# Information Notice

## OBSOLESCENCE INFORMATION NOTICE

AIRCRAFT CONCERNED	Version(s)	
	Civil	Military
EC155	B, B1

**SUBJECT:** LIGHTS – Position lights  
Obsolescence of the tail position light

**Figure 1: Removal / Installation of tail position light**

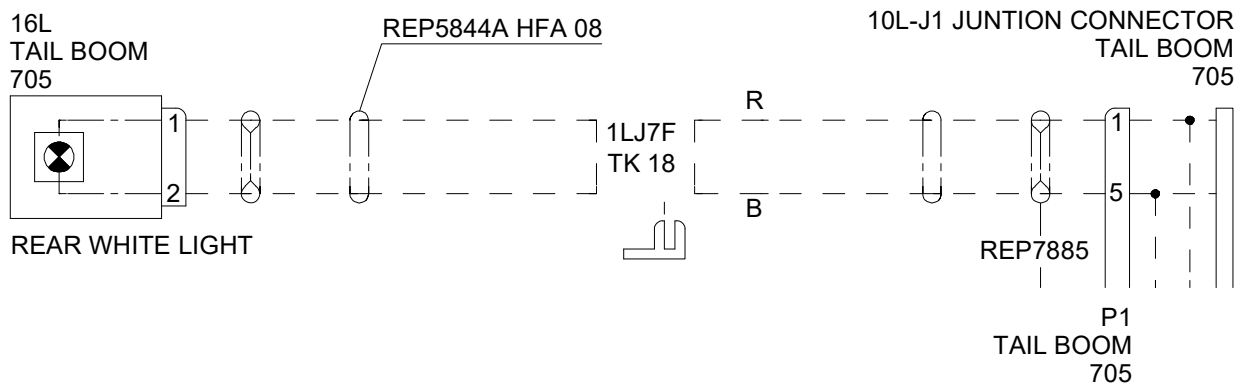
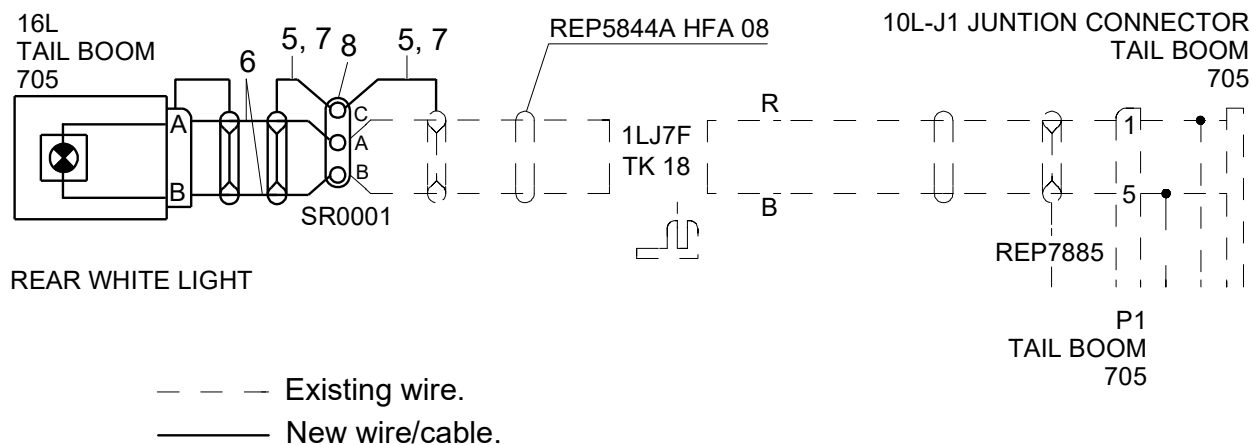
1. Remove the existing tail position light (3, Fig. 1) (AMM 33-41-01-062). Discard the tail position light (3).
2. Remove the existing adapter (17), with the screws (1) and washers (2). Discard the adapter (17).

3. Installation of the new tail position light (3):
  - a. If the existing wires in the helicopter are long enough, go to step c.
  - b. If the existing wires in the helicopter are not long enough:

- <sup>1</sup> Fix the light retainer cable (16) with one screw (1) and one washer (2) during the installation.
- <sup>2</sup> Installed with locking compound (CM 620).
- <sup>3</sup> Replace if needed.
- <sup>4</sup> Seal the union between the helicopter and the tail position light (3) with sealing compound (CM 6001).
- <sup>5</sup> Pre SB.
- <sup>6</sup> Post SB.

- i. Connect connector (14) to the tail position light (3).
  - j. If the existing label (4, Fig. 1) is damaged, replace it with a new label (4). Write "16L" on the label (4) using a permanent marker.

- k. Attach the tail position light (3) to the helicopter with three screws (1), three washers (2) and the light retainer cable (16) of the tail position light (3).
- l. Secure the screws (1) with locking compound (CM 620). Let the locking compound dry, refer to the manufacturer's instructions.
- m. Seal the joint between the helicopter and the tail position light (3) with sealing compound (CM 6001). Let the sealing compound dry, refer to the manufacturer's instructions.

**Figure 1: Removal of the lateral position light**

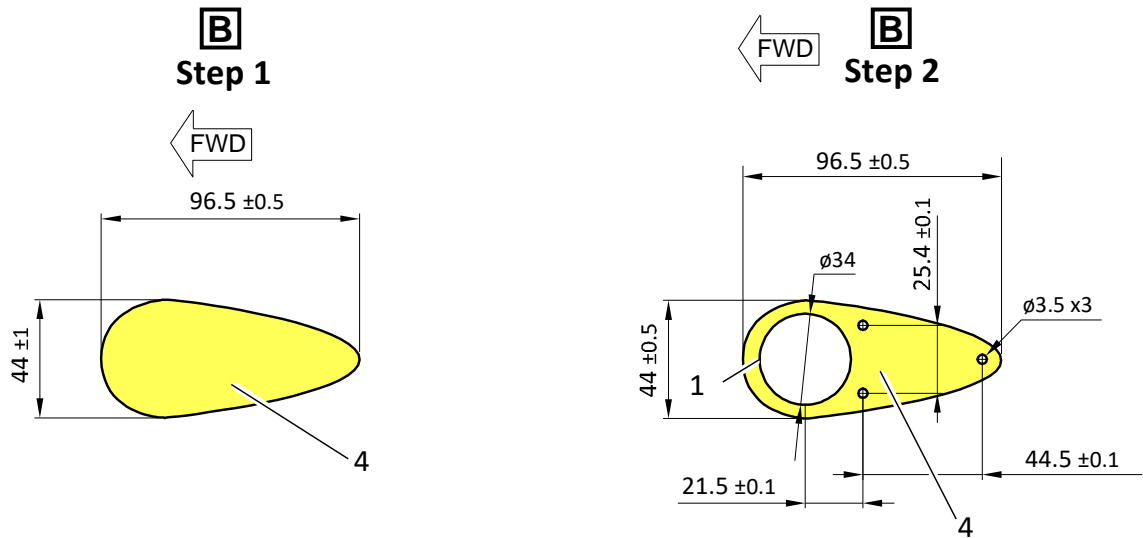
1. Remove the lateral position light (2, Fig. 1) (AMM 33-41-01-061). Discard it.
2. Do a check of the inserts (4, Fig. 1) installed in the end-plate (1):

- a. If the inserts (4) are size M3, go to step 4.
  - b. If the inserts (4) are not size M3, do the procedure that follows:
    - Remove the inserts (4) (MTC 20-02-08-406).

If the inserts (4) are removed, check if the holes of the inserts touch the edge of the borehole (5).

Figure 2: Replacement of the inserts

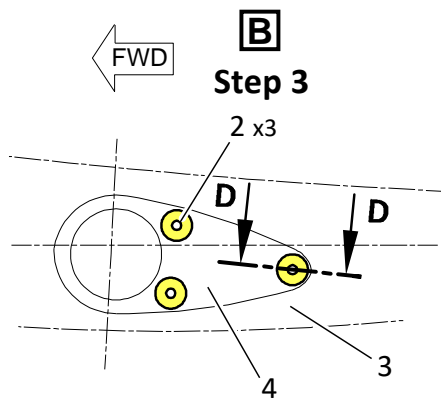
- Do a check of the holes of the inserts:
      - If the holes of the inserts do not touch the edge of borehole (5), install three inserts (2, Fig. 2) with colle (CM 616) (MTC 20-02-08-406) in the end-plate (3). Go to step 4.

- If the holes of the inserts touch the edge of the borehole (5, Fig. 1), continue with step 3.
3. Repair the installation area of the inserts (2, Fig. 2) as follows:

- Repair the edge of the borehole (1) with colle (CM 616). Let the colle dry, refer to the manufacturer's instructions.
  - Pre-cut one layer of fabric (CM 7246) with an enlarged size relative to sizes as shown in View B Step 1.

- Cure in accordance with the manufacturer's specifications or MTC 20-03-06-406.
  - Remove unwanted colle (CM 616).
  - Drill three holes with a drill bit diameter of 3.5 mm in the layer of fabric (CM 7246) (4), as shown in View B Step 2.

- Deburr boreholes diameter 3.5 mm and clean work areas (MTC 20-04-01-401).
  - Install the three inserts (2) with colle (CM 616) in the end-plate (3) (MTC 20-02-08-406).

**Figure 3: Installation of the lateral position light**

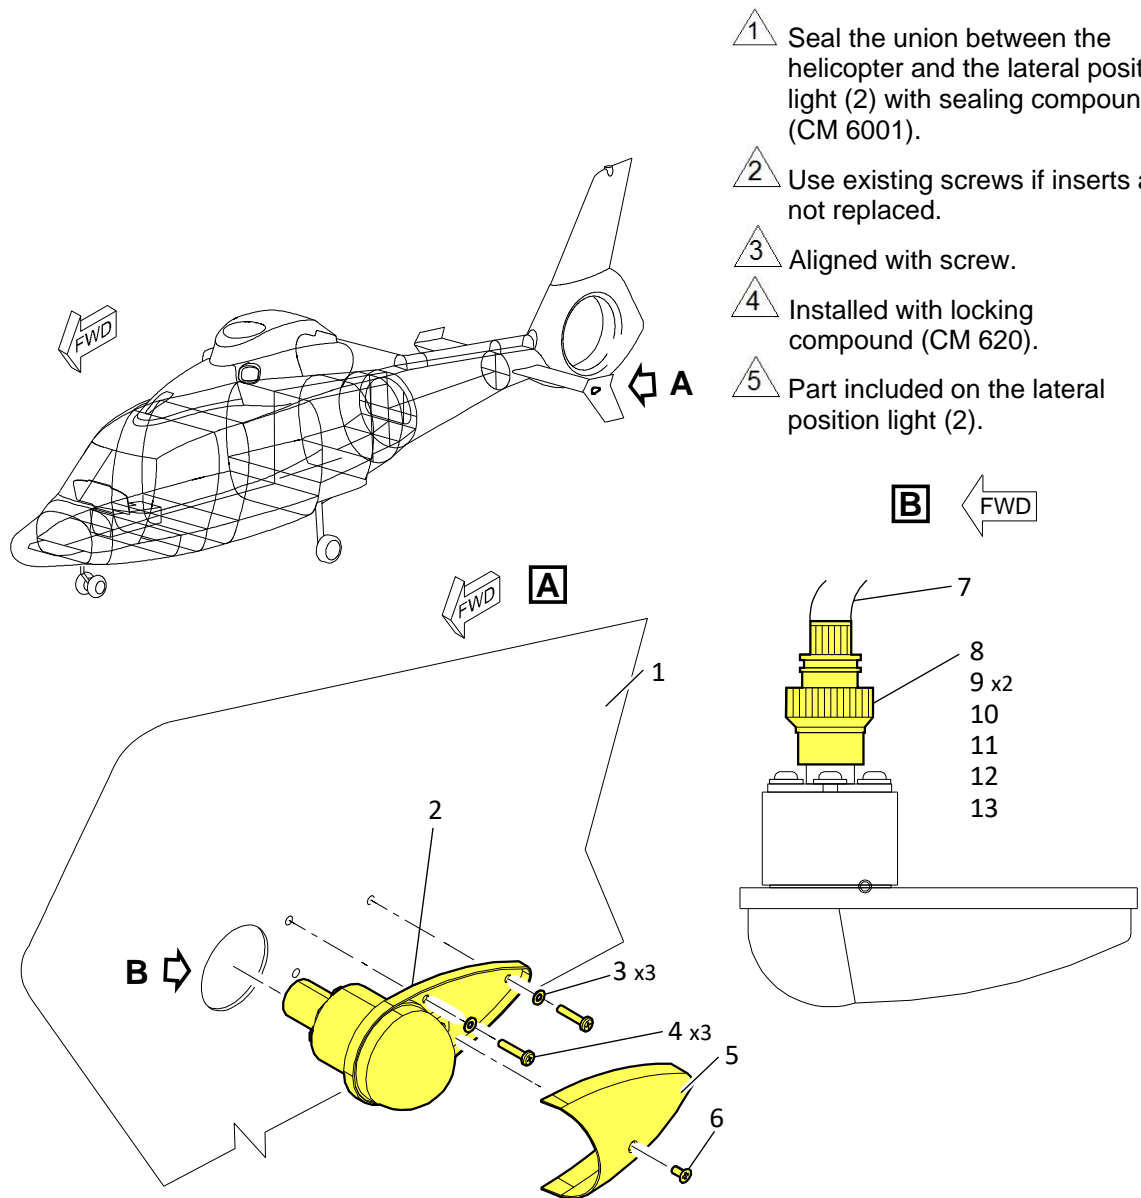
- Paint the end-plate (3) with the same paint as the helicopter. Let the paint dry, refer to the manufacturer's instructions.
4. Install the lateral position light (2, Fig. 3) as follows:

- j. Apply locking compound (CM 620) to the screws (4, Fig. 3).
  - k. Install the lateral position light (2, Fig. 3) on the end-plate (1) with the screws (4) and washers (3). Align the washers with the screws.

- ① Seal the union between the helicopter and the lateral position light (2) with sealing compound (CM 6001).
- ② Use existing screws if inserts are not replaced.
- ③ Aligned with screw.
- ④ Installed with locking compound (CM 620).
- ⑤ Part included on the lateral position light (2).

- l. Seal the joint between the helicopter and the lateral position light (2, Fig. 3) with sealing compound (CM 6001). Let the sealing compound dry, refer to the manufacturer's instructions.

- m. Apply locking compound (CM 620) in the screw (6, Fig. 3).
  - n. Install the cover (5, Fig. 3) on the lateral position light with the screw (6). Let the locking compound dry, refer to the manufacturer's instructions.

**Figure 4: Wiring Diagram**

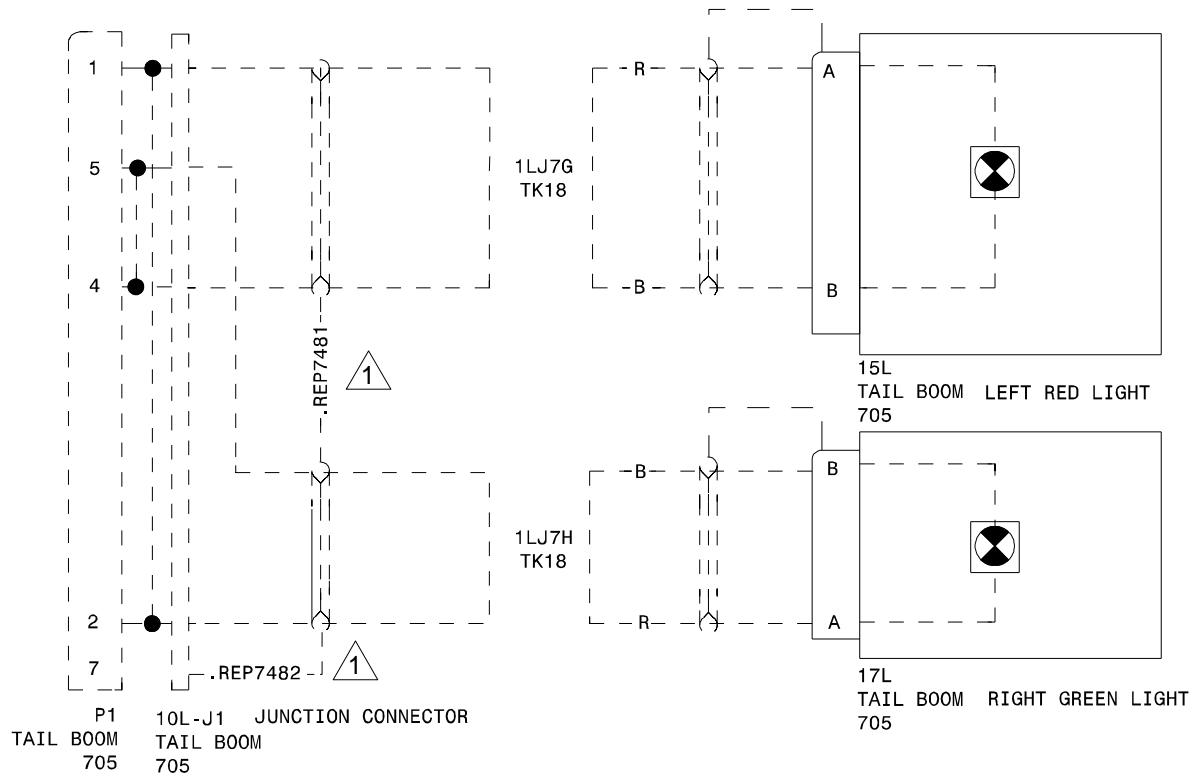
- a. Strip the wires of the existing cable (7) and crimp on contacts (9) (MTC 20-80-20-408). Refer to the Wiring Diagram (Fig. 4).
  - b. If is not installed, connect cable shielding on the existing wires. Refer to the Wiring Diagram (Fig. 4).
